DFDS submissions for Deadline 5 - Immingham Eastern Ro-Ro Terminal DCO

IMMINGHAM EASTERN RO-RO TERMINAL DCO APPLICATION

PINS REFERENCE TR030007

COMMENTS ON DEADLINE 4 SUBMISSIONS BY DFDS

Figure 1- Indicative illustration of the movements of the Fast Ann on 19 January 2010

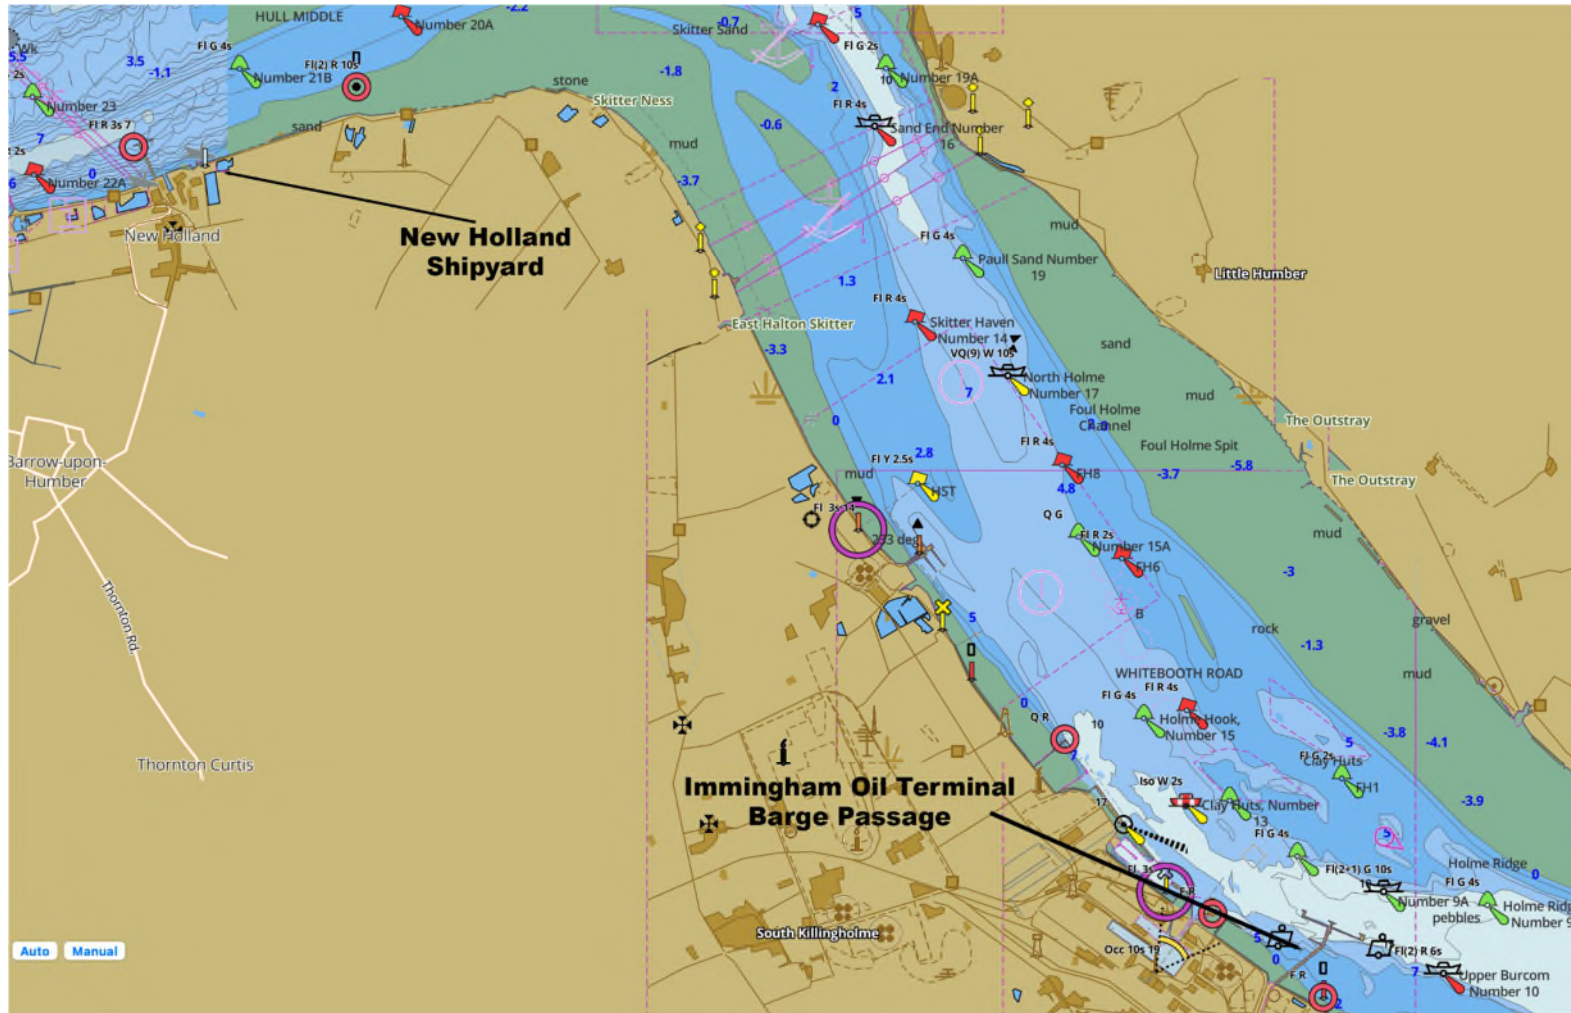
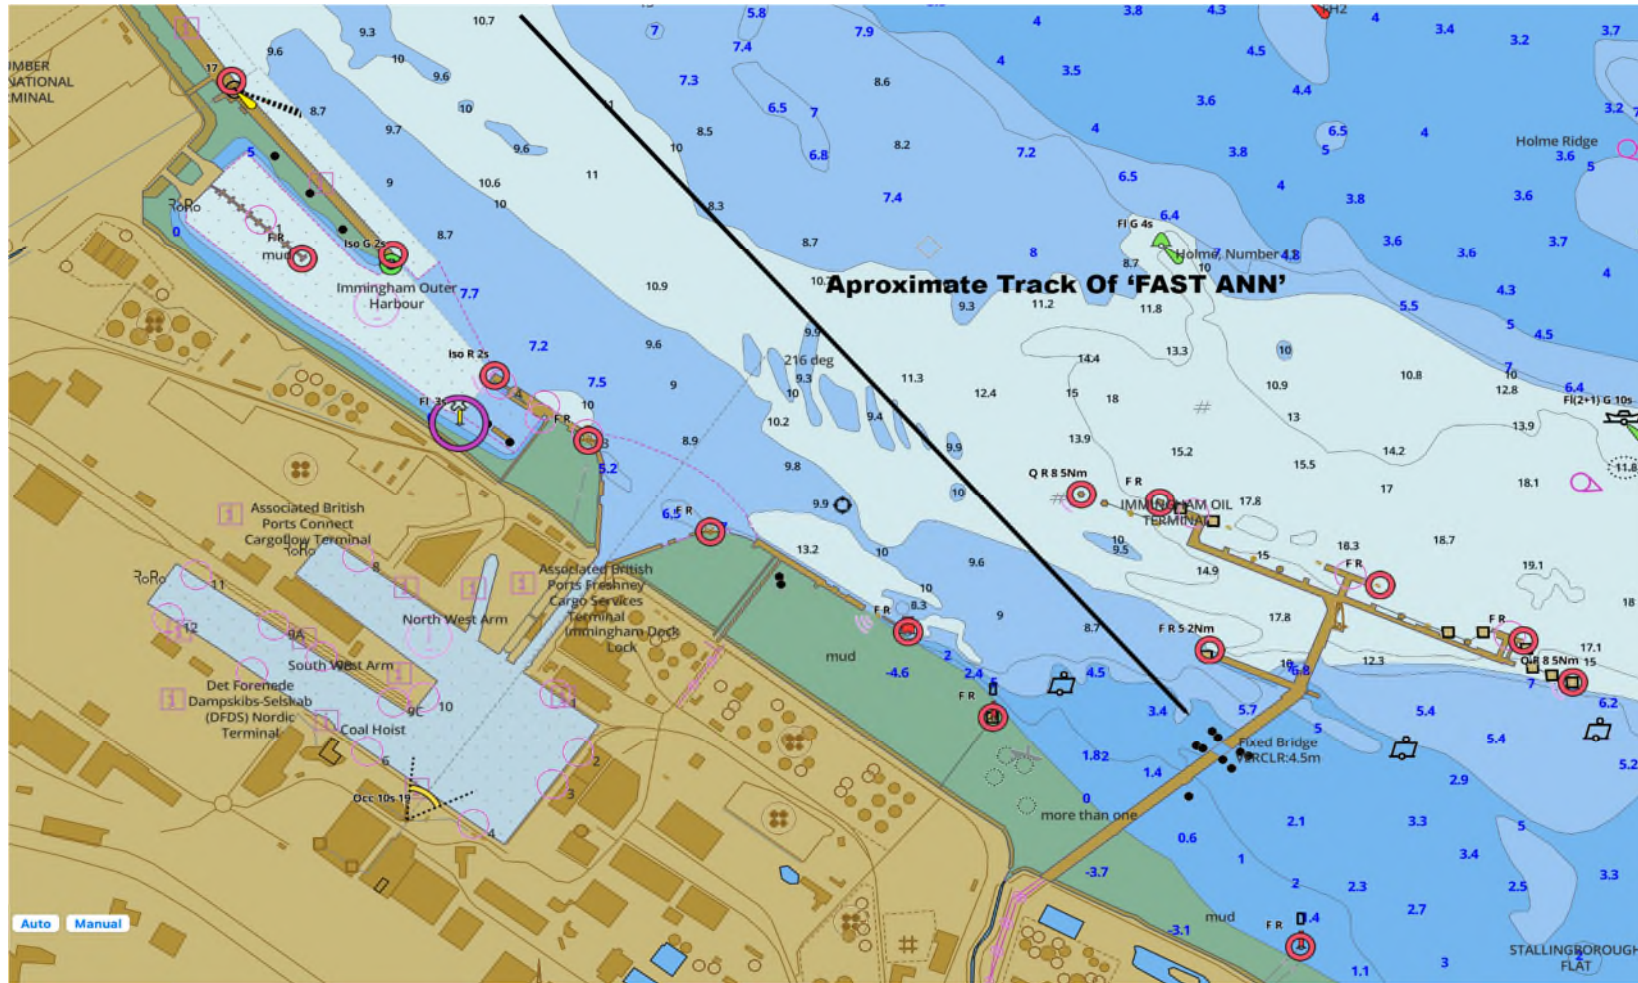
65. We would also draw the ExA's attention to the 'Fast Ann' incident 19 January 2010 (the MAIB's summary is provided on e-page 75 of **REP4-023**). In this incident a vessel which had been beached at New Holland Breakers yard for decommissioning parted her moorings on the ebb tide in dense fog. She was carried downriver by the tide and despite the best efforts of local tugs eventually had an allision with the IOT trunk way in the vicinity of the barge passage. Her path clearly shows that the tide has taken her in a direction roughly consistent with the previously accepted 135° direction of tidal flow, see Figures 1 and 2 below.

Figure 3 – Radar image from DFDS vessel bound for IOH in August 2022 passing IOT 1 in dense fog.

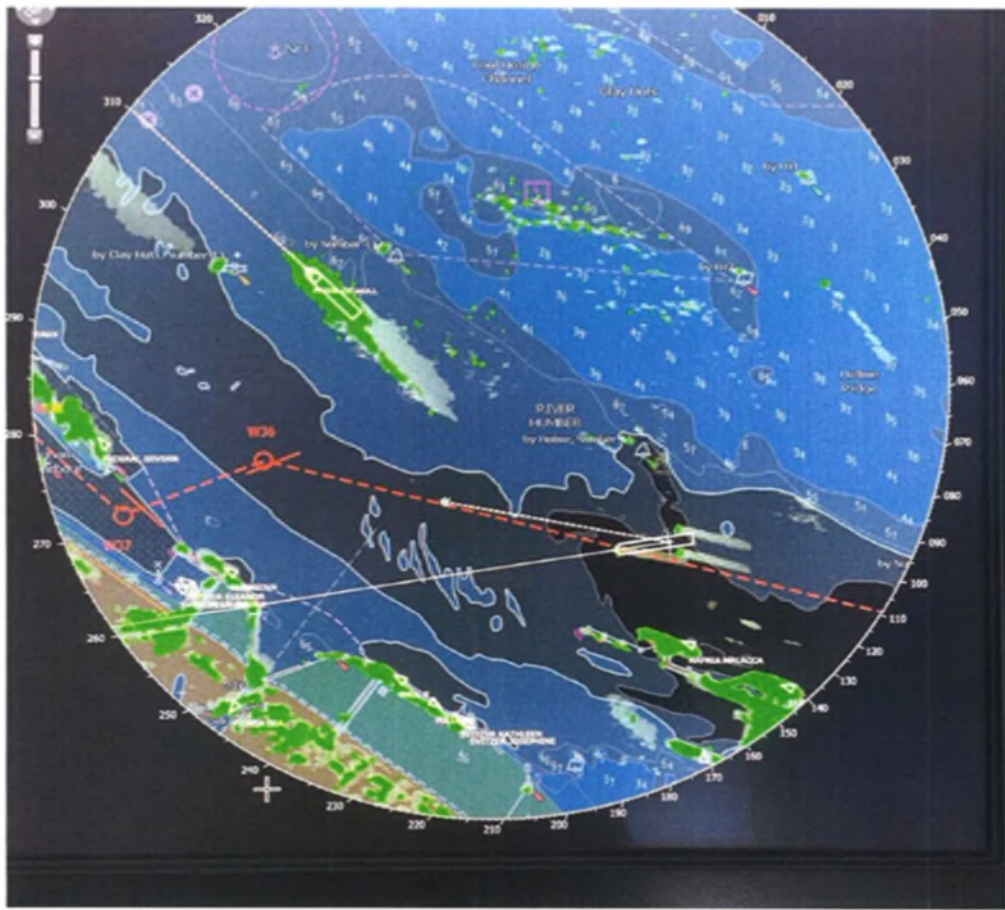
66. Figure 3 below shows an image taken from the radar of a DFDS vessel bound for IOH in August 2022 passing IOT 1 in dense fog (and therefore no wind), which clearly shows the vessels heading of 262° (solid white line) and a course over the ground (dotted white arrow) of 285° which can only be caused by the impact of the flood tide acting in a direction greater than 292° (line of IOT).
